NL-11-1543

Joseph M. Farley Nuclear Plant – Unit 1  
Response to NRC Request for Additional Information –  
Proposed Relief Request FNP-ISI-RR-01

**Response to NRC RAI Regarding Proposed Relief Request FNP-ISI-RR-01  
for Farley Nuclear Plant, Unit 1**

FARLEY 1  
 OUTLET SAFE END DETECTION SCANS  
 25° ALA1-4100-1DM  
 145° ALA1-4300-1DM  
 265° ALA1-4200-1DM  
 FIGURE 1

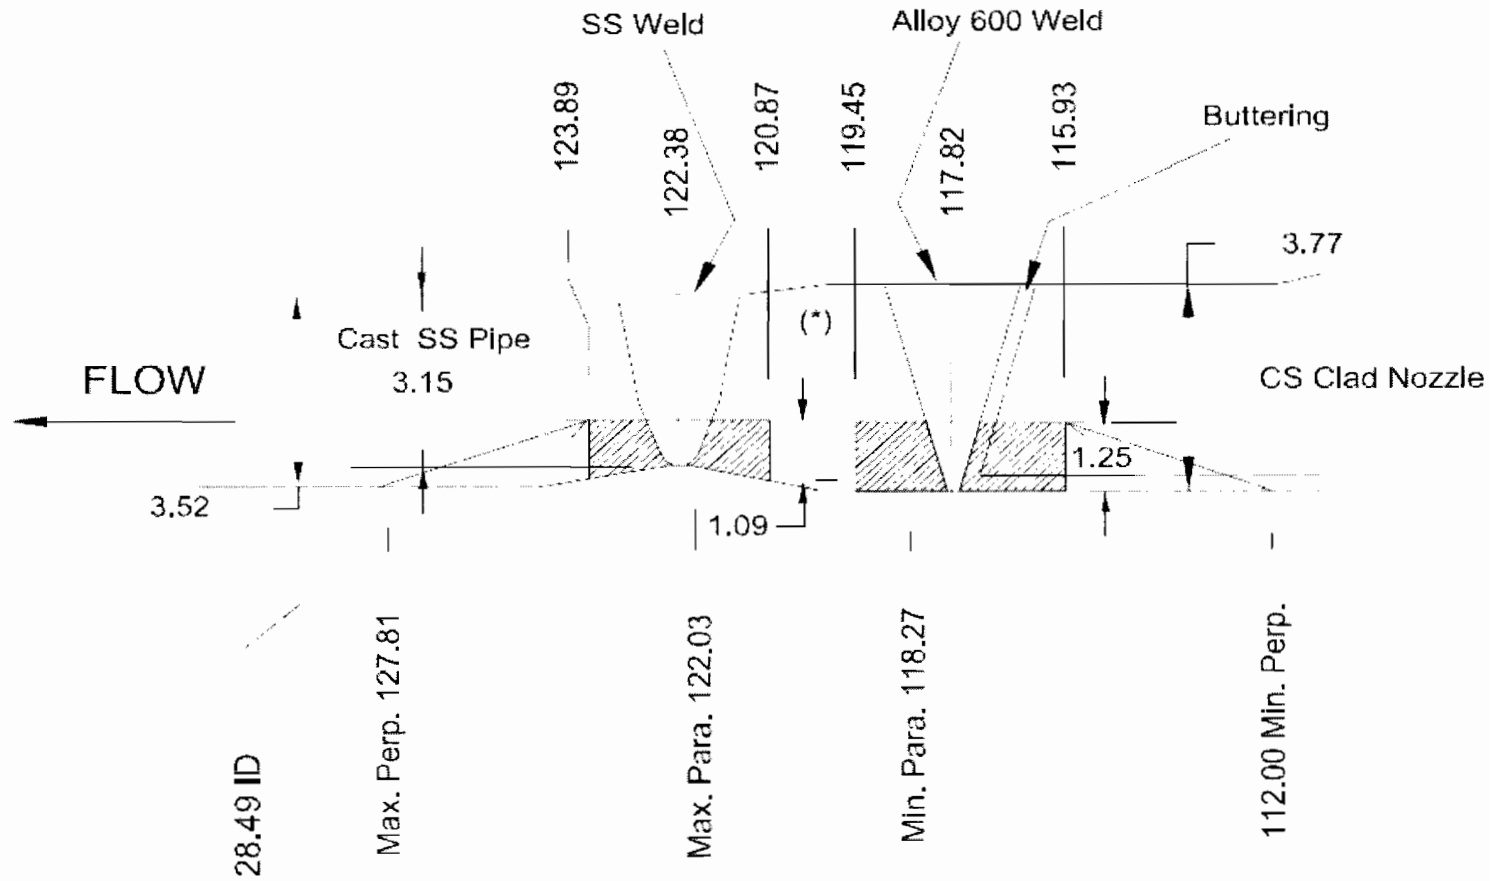
Some details about the welds were not included in the relief request. Provide detailed cross-sectional diagrams including sketches of the weld area. These diagrams should identify the materials (stainless steel, carbon steel, nickel alloy) of the base metal, weld, and buttering and show dimensions (Nominal inside diameter (ID), outside diameter (OD), and wall thickness) for each of the welds.

Figures 1 and 2 show the hot-leg and cold-leg drawings, respectively. The drawings show both configuration and materials.

FARLEY 1  
25° Hot Leg Loop 1  
FIGURE 3

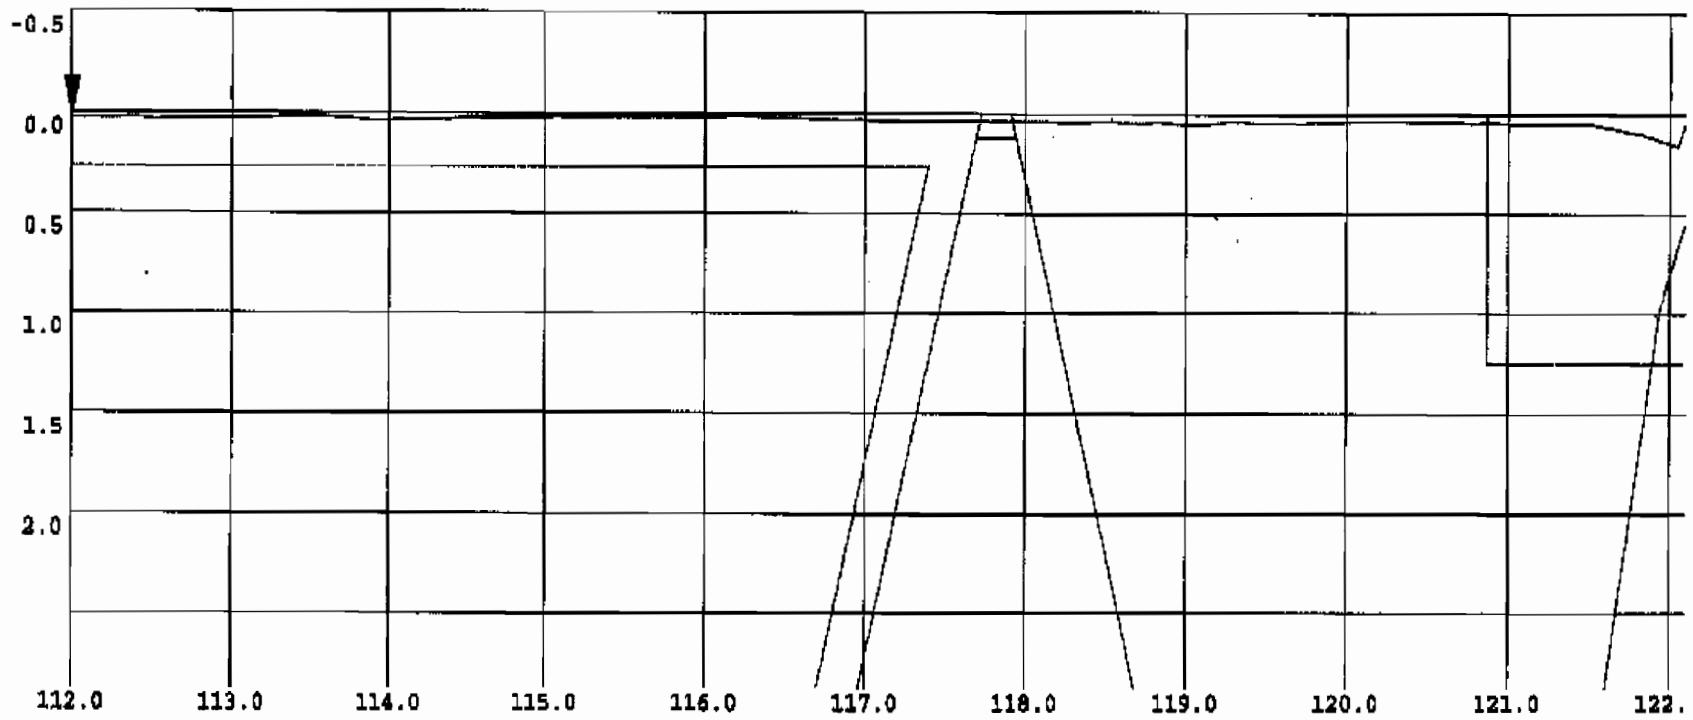
Has profilometry been previously performed on any of these welds? If yes, provide a description of the surface waviness and estimate the percentage of areas with suspected probe lift-off.

Profilometry using UT methods was performed on the ID surface during the fall 2007 1R21 outage at Unit-1. The surface condition of the nozzle to safe-end welds were relatively smooth with no lack of coverage noted. A more recent examination on Farley-2 was completed during the fall 2008 2R19 outage with similar results. Figures 3, 4, and 5 provide representative profilometry profiles for Farley-1 hot-leg nozzles.
